### MILWAUKIE PLANNING COMMISSION Tuesday, October 13, 2015, 6:30 PM

- 5.0 **Public Hearings** – Public hearings will follow the procedure listed on reverse
  - 5.1 Summary: Riverway Ln Pool/Slope Project  
Applicant/Owner: Gary Klein  
Address: 10795 SE Riverway Ln  
File: NR-2015-003  
Staff: Brett Kelter

**To:** Planning Commission

Existing Conditions

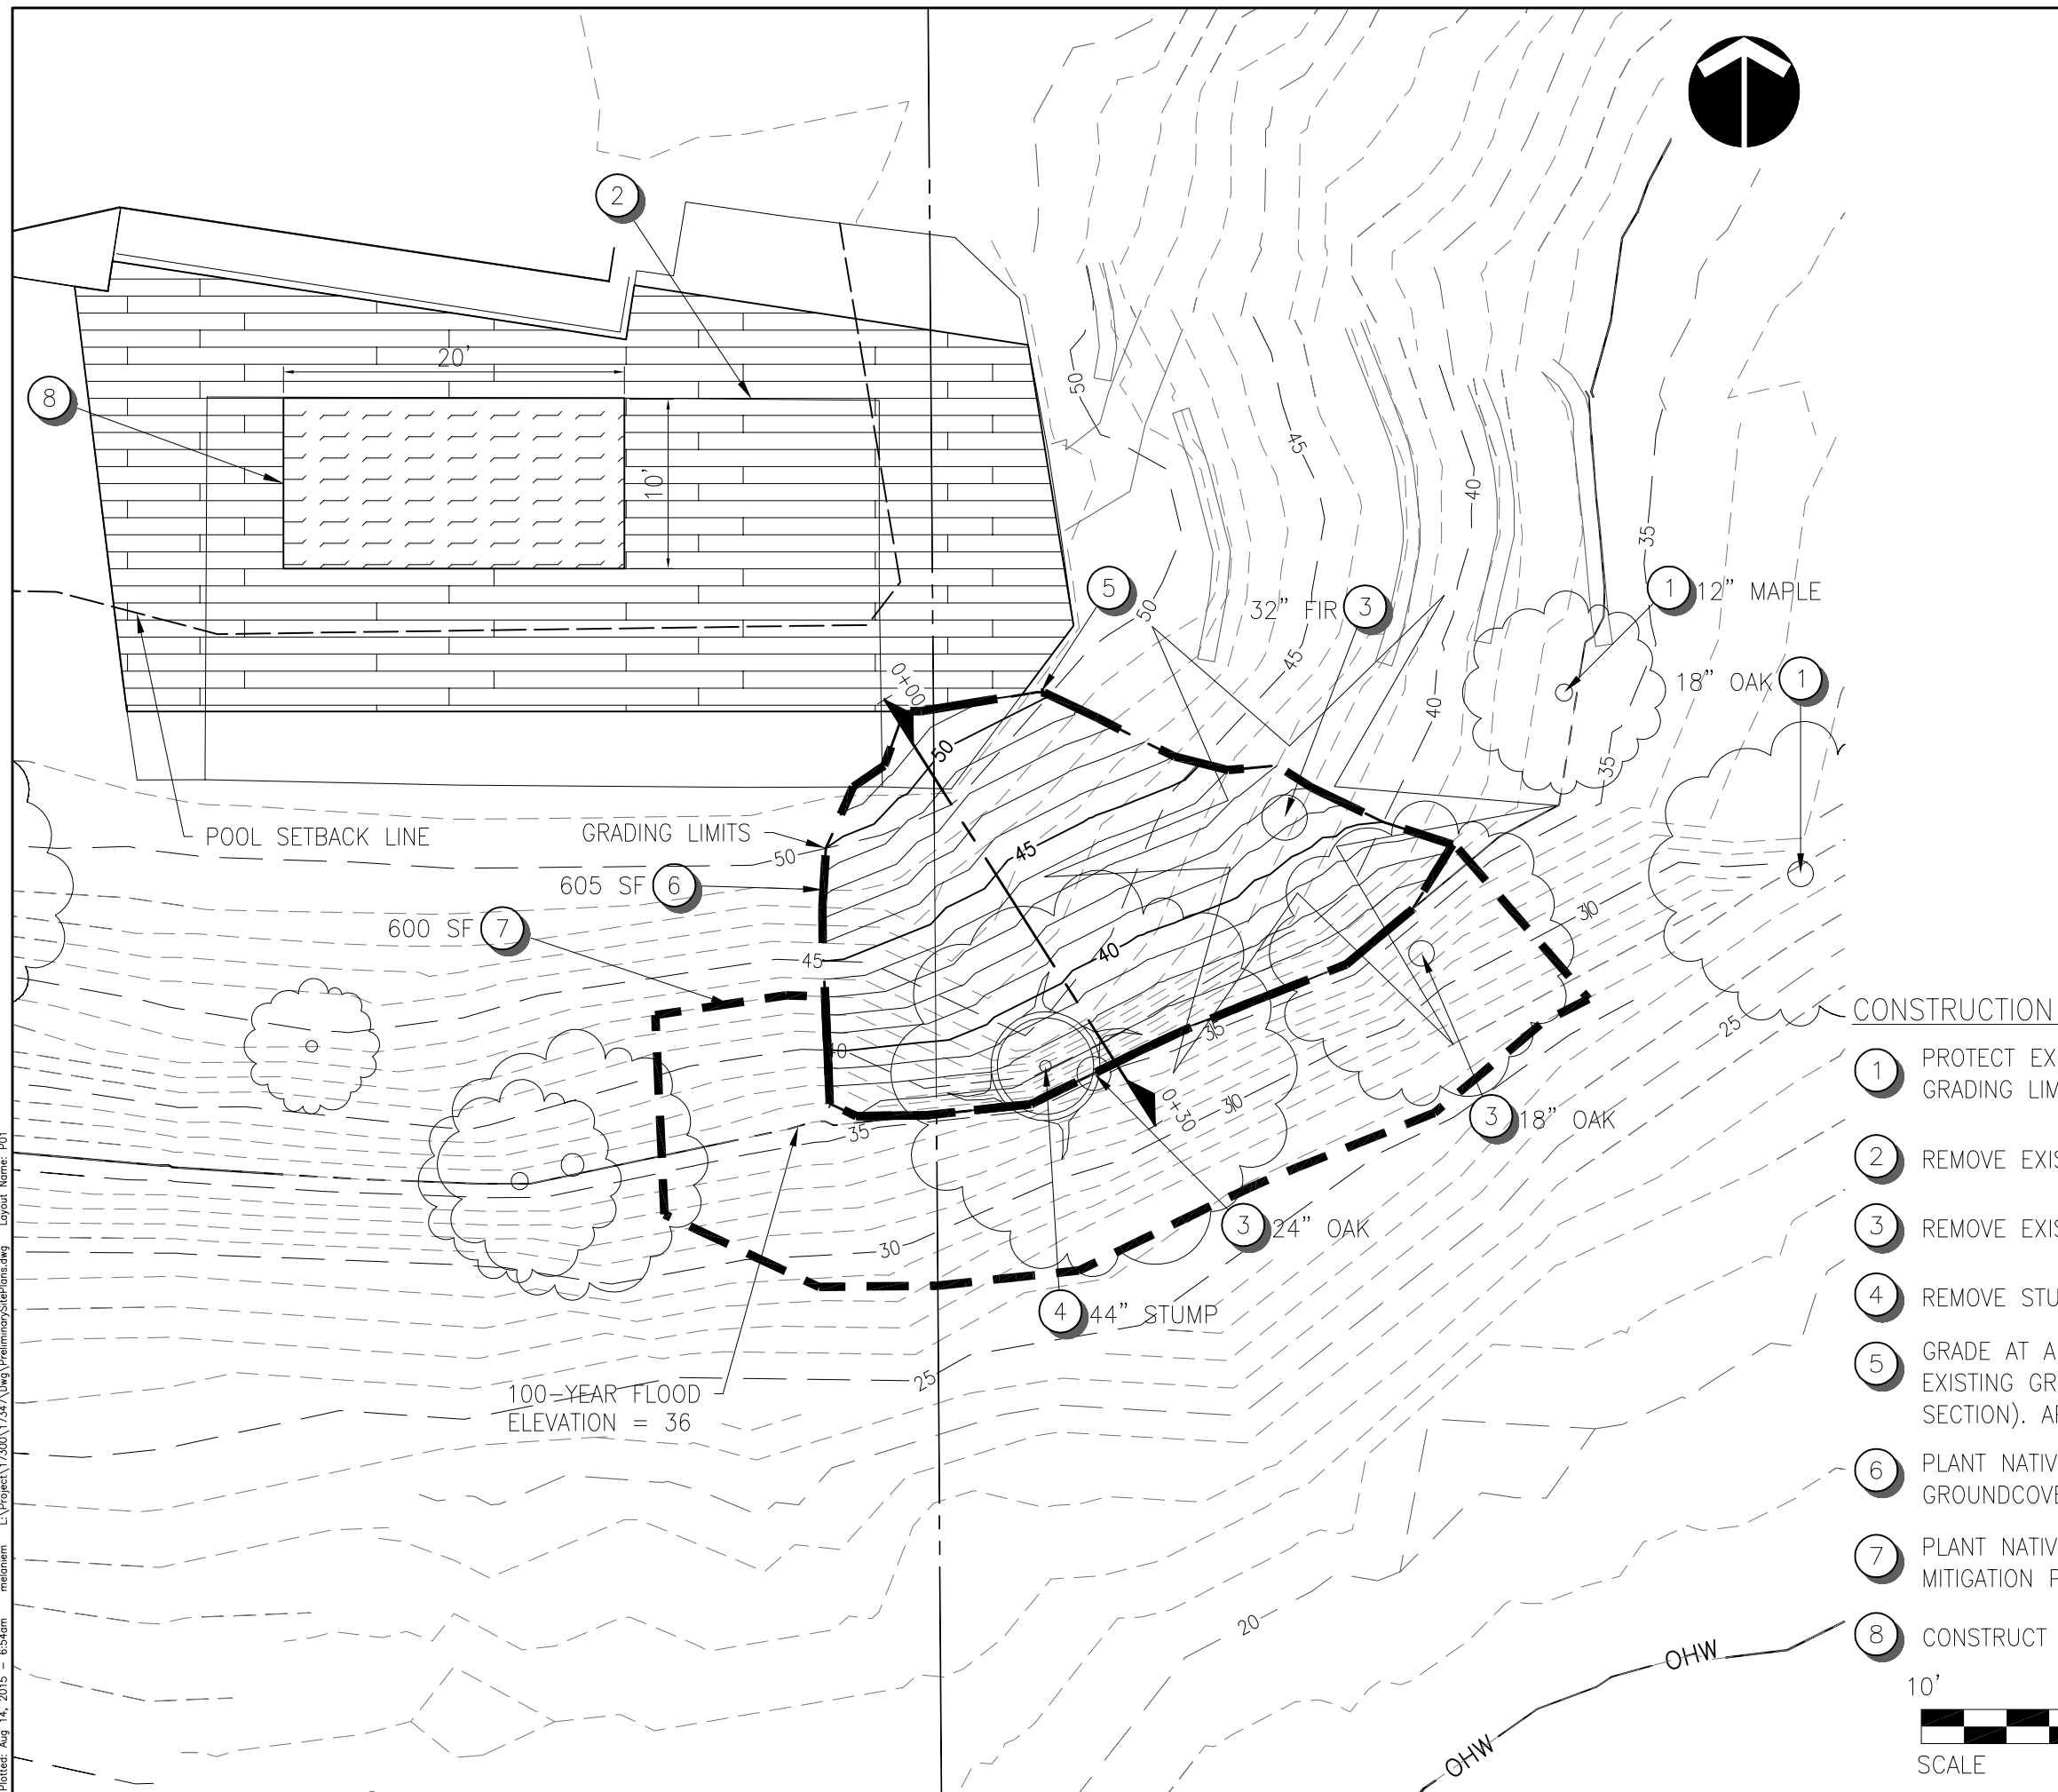
- (1) Existing Conditions (Drawing E01)
  - (2) Existing Natural Resource Overlays (Figure 1 in Impact Evaluation section)
  - (3) HCA Boundary Verification (Figure 3 in Impact Evaluation)

Henmi Global Partner  
 806 SW 380 Ave., Suite 300  
 Portland, OR 97204  
 Phone: (503) 287-6825  
 Fax: (503) 415-2304  
 www.otak.com  
 17347  
 Project No. Drawing No.  
**Figure 4**  
 Sheet No.  
 © 2014 Otak, Inc.

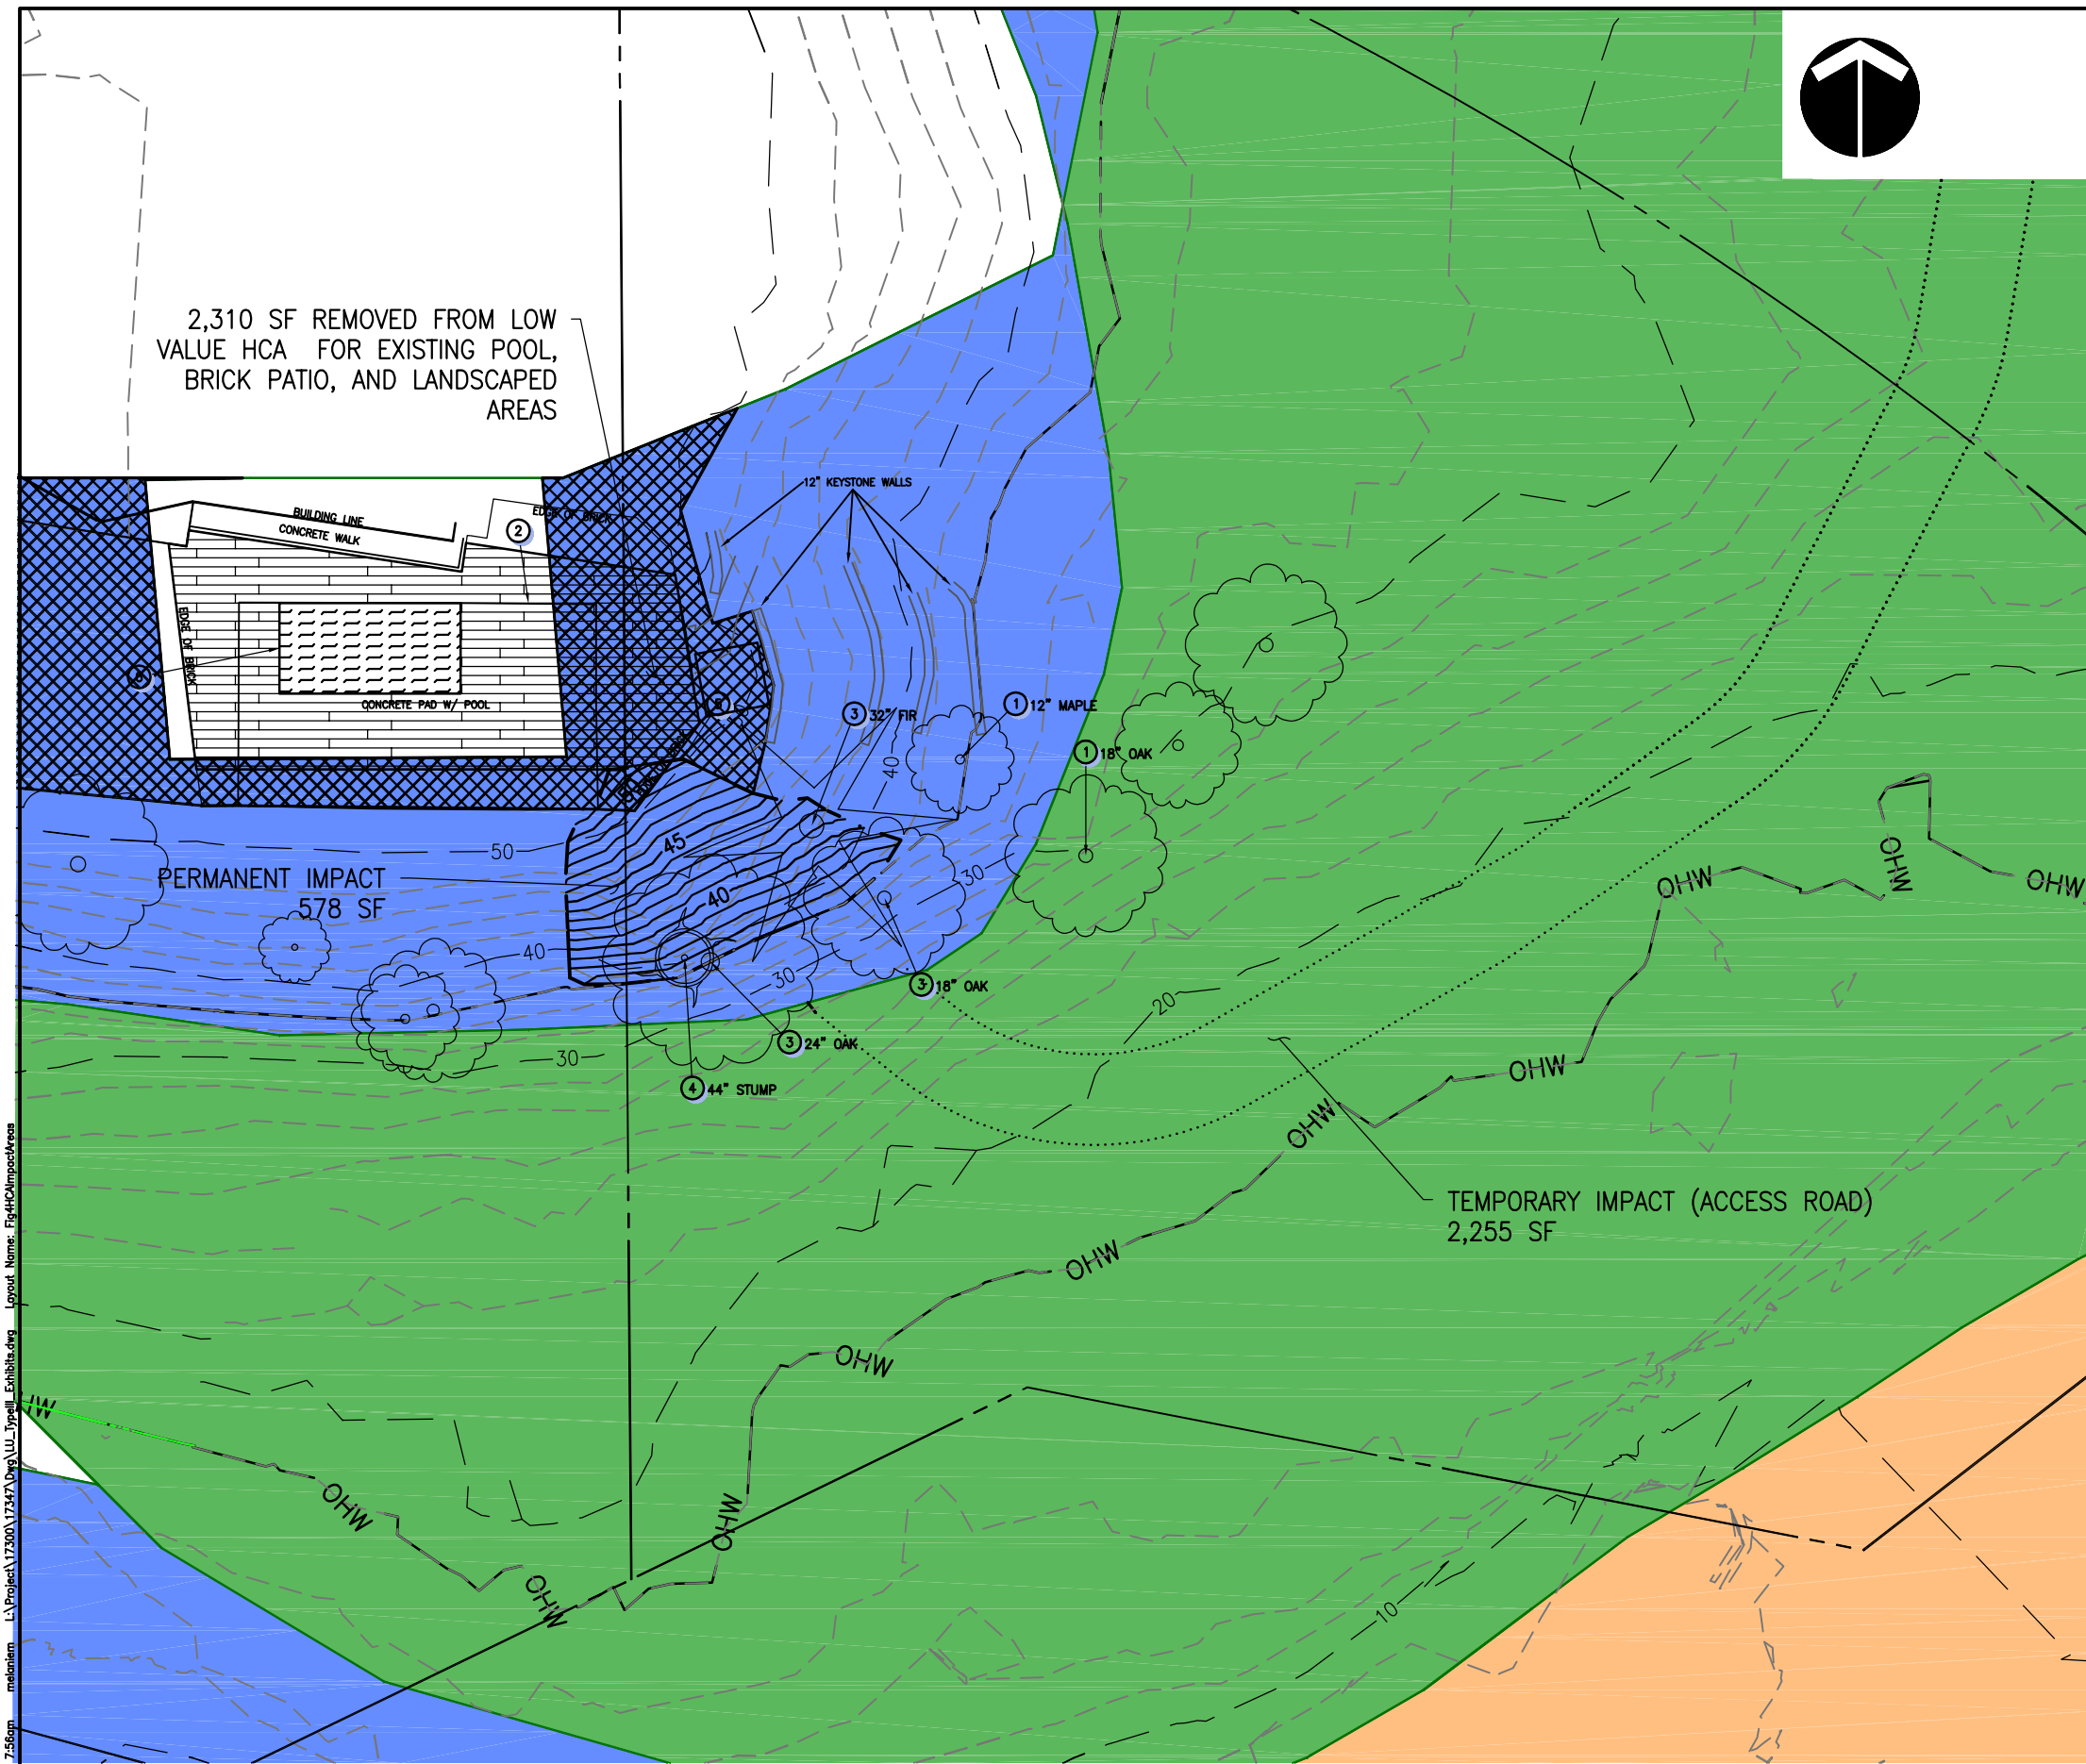
- Provide revised versions of key site plans, adjusting the representations of the location of Water Quality Resource (WQR), Habitat Conservation Area (HCA), and Willamette Greenway vegetation buffer.
- Provide an adjusted figure for WQR and HCA disturbance and a recalculation of mitigation plantings, at the ratio of 5 trees and 25 shrubs per 500 sq ft of disturbance.
- Provide a planting site plan showing the general locations and/or distributions of the various species, to ensure that species are located appropriately for the site conditions based on their various characteristics. The plan shall demonstrate that, to the greatest extent practicable, trees removed from the project area will be left within the WQR and/or HCA, to preserve the riparian habitat functions the downed trees would serve if left to fall naturally over time.

- (4) Preliminary HCA Impacts (Figure 4 in Impact Evaluation)
  - (5) WQR Impacts (Figure 5 in Impact Evaluation)
  - (6) Willamette Greenway Vegetation Buffer Impacts (Figure 1 in Mitigation Plan)

- (7) Mitigation Activities (Figure 2 in Mitigation Plan)
  - (8) Construction Management Plan (Figure 1)
- e. Based on the revised site plans noted in Condition 1-d, provide an adjusted figure for WQR and HCA disturbance and a recalculation of mitigation plantings, at the ratio of 5 trees and 25 shrubs per 500 sq ft of disturbance.
